City of Tacoma

**ADDENDUM NO. 2**

**Request for Bids Specification No. PW23-0090F  
TPU S 17th St Court D/E**

N.T.S.

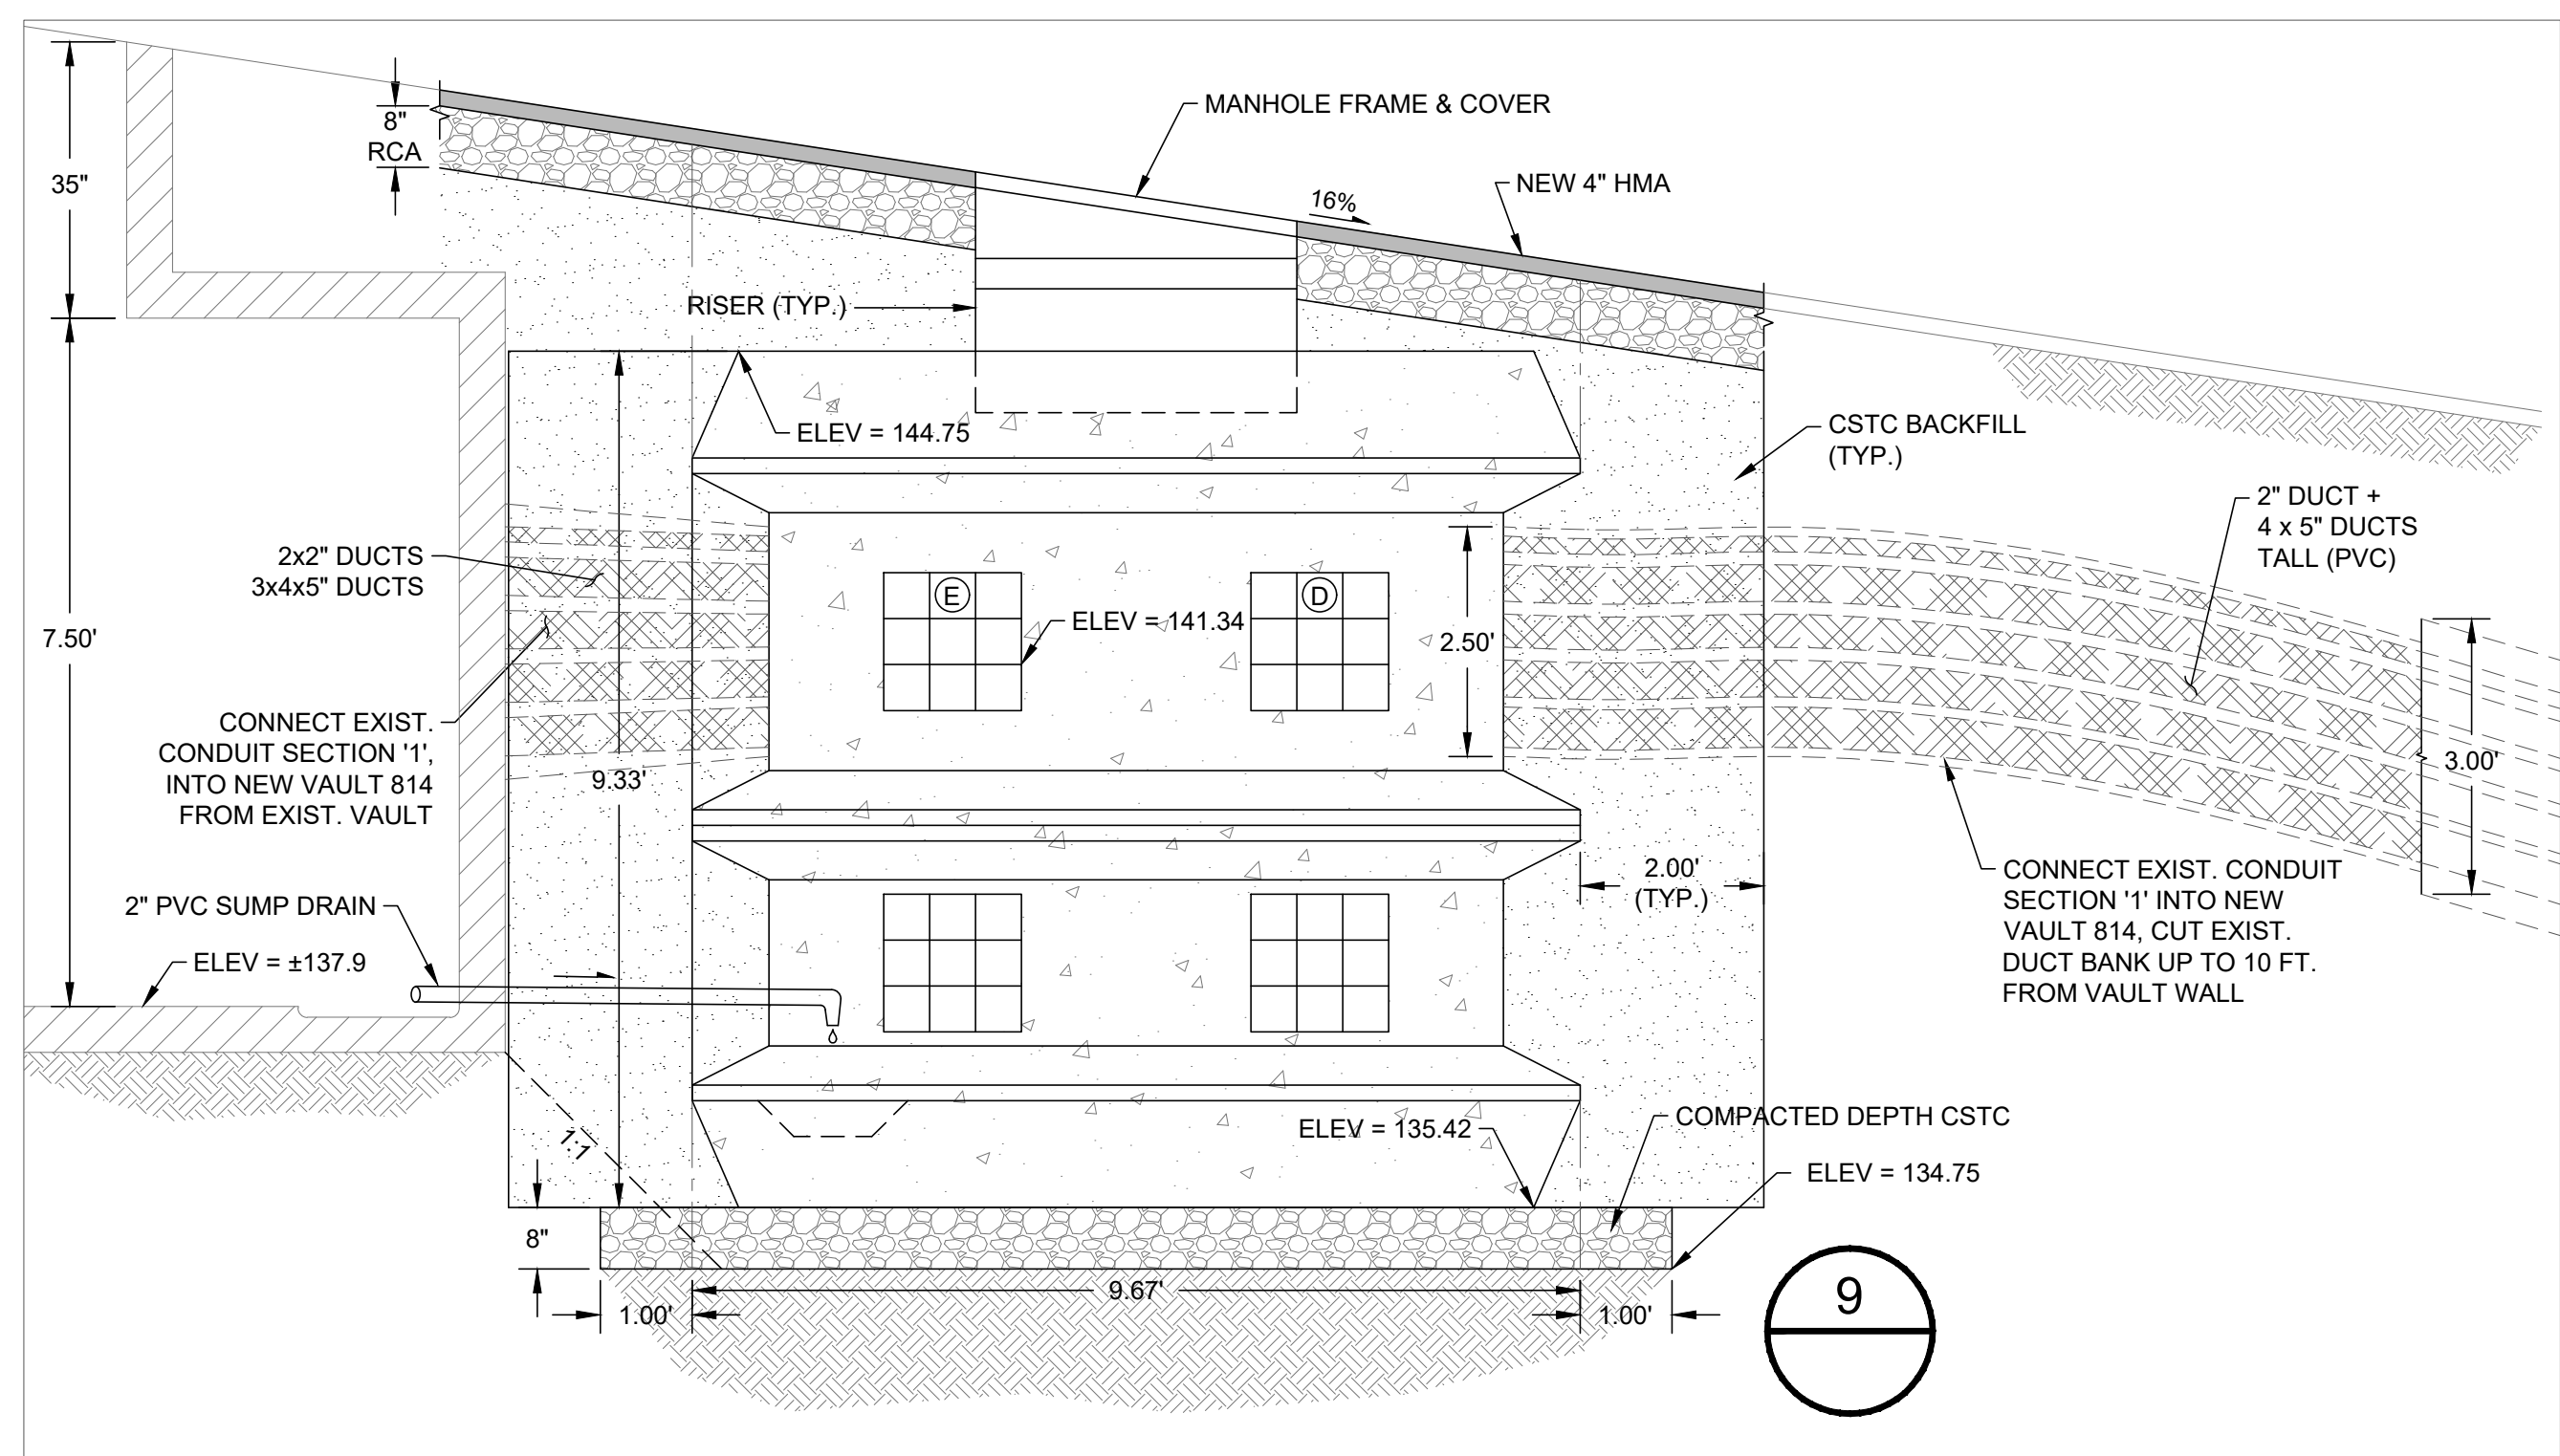
1. Sheet No. 7 / Sheet DTL-4 of DTL-4
2. Sheet No. 8 / Sheet D-1 of D-1
3. Sheet No. 10 / Sheet C-2 of C-2
4. Sheet No. 12 / Sheet PW-1 of PW-1

NOTE:  
CONTRACTOR SHALL VERIFY WITH  
MANUFACTURER SHOP DRAWINGS FOR  
ACCURATE FOUNDATION ELEVATIONS  
AND EXCAVATION LIMITS
